R15YB

IMPORTANT SAFETY RECALL NOTICE

**NHTSA RECALL NO. 15V059 SCHOOL BUS
NHTSA RECALL NO. 15V060 NON-SCHOOL BUS**

Potential for Rear Engine Exhaust Hangers Failing

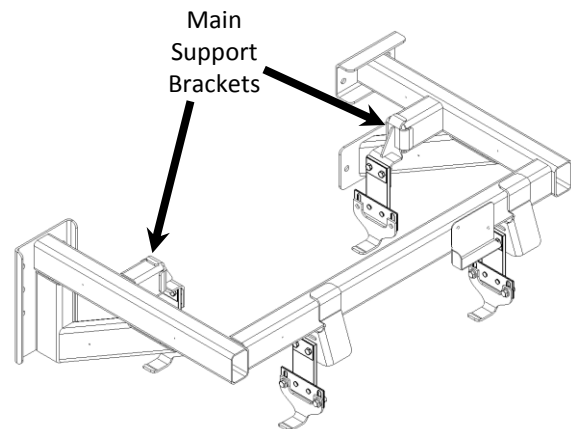
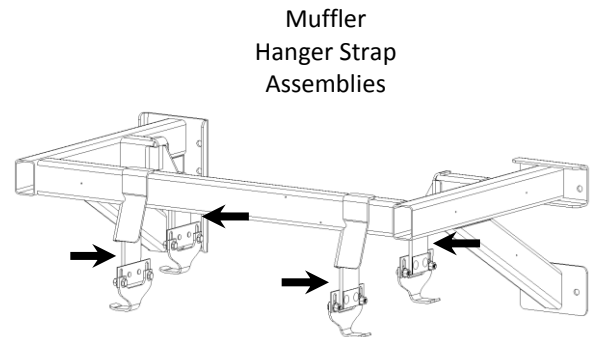
The rubber SCR and DPF hanger strap assembly may fail under extreme conditions causing extensive damage to the SCR and DPF modules.

Install new exhaust hanger strap assembly 10040843 (4 Places); and exhaust support cables, 10040841.

1. Park the bus on a level surface, apply parking brake, turn off engine, remove ignition key, and chock wheels.
2. Locate the four muffler hanger strap assemblies supporting the SCR and DPF at the rear of the bus.

Note: Inspect welded Main Support Brackets for damage (bent brackets or cracked welds) before installing new muffler hanger bracket assemblies. Replace, as needed.

3. Support the SCR and DPF, and replace muffler hanger strap assemblies (4 Places) with new assemblies 10040843 and add two exhaust support cables 10040841, two bolts 00803171, two nuts 00543934, and two nuts 02171809 per exhaust hanger strap assembly. Drill out slots at eight (8) mounting locations to 13/32 inch diameter. Do not reuse old nuts.

Torque upper 3/8" nut that comes with new bracket assembly 10040843 to 72 – 78 in-lb.

4. Torque lower 3/8" nuts (00543934 and 02171809) to 29 - 33 lb-ft. See Sheet 2 for illustration.
